Written Representation to the Examining Authority (ExA) regarding the Environmental Statement submitted by Tritax Symmetry (Hinckley) Ltd in respect of their proposed Hinckley National Rail Freight Interchange and with particular reference to Chapter 10: Noise and vibration

Unique Reference Number: 20040614

This Written Representation is with particular reference to Chapter 10: Noise and vibration, reference: 6.1.10, revision 07 [APP-119] and its associated documents.

CHART 3.
CORRECTION FOR DISTANCE, d'

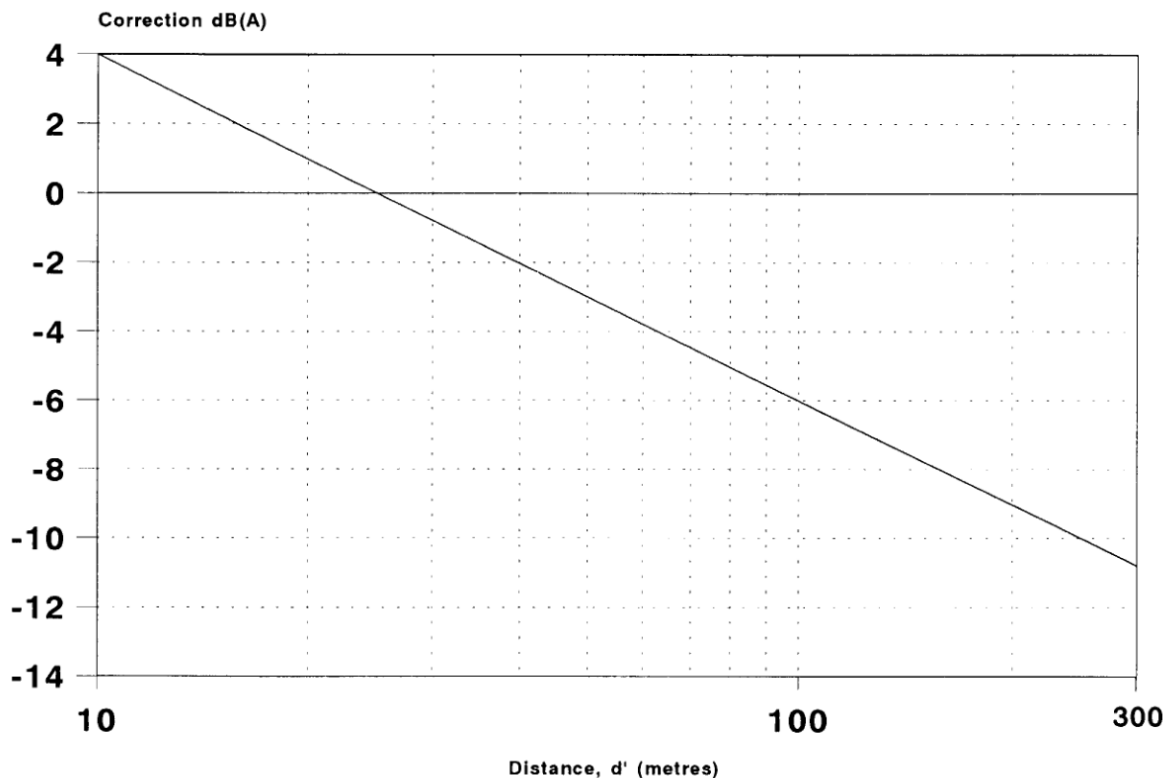
Simple calculations I have performed in accordance with CRN with respect to NMP4 confirm that the rate of attenuation is such that, at some modest distance from the railway line, the ambient noise value, L_{Aeq} , falls very significantly compared with the ambient noise value that was measured at the Noise Monitoring Position NMP4. This is in accordance with the everyday experience of local residents, and indeed with common sense.

By way of illustration, I show below Chart 3 from CRN which indicates, in broad terms, how train noise is attenuated by distance.

Fortunately, to resolve this issue, Chart 3 of CRN, which I have already shown above, describes how train noise is attenuated over distance. With reference to Chart 3 and also the attending logarithmic formula, it can be seen that in order to convert noise monitoring results at 12 metres to those in

accordance with the CRN standard “notional receptor” at 25 metres, a value of 3.2dB needs to be subtracted from the noise monitoring measurements.

What this means in practice is that for the NMP4 measurements, a value of 3.2dB needs to be subtracted from the ambient L_{Aeq} and maximum $L_{Amax,f}$ noise values in Tables 10.20 to 10.25. The background L_{A90} noise levels will in contrast be almost completely unaffected.
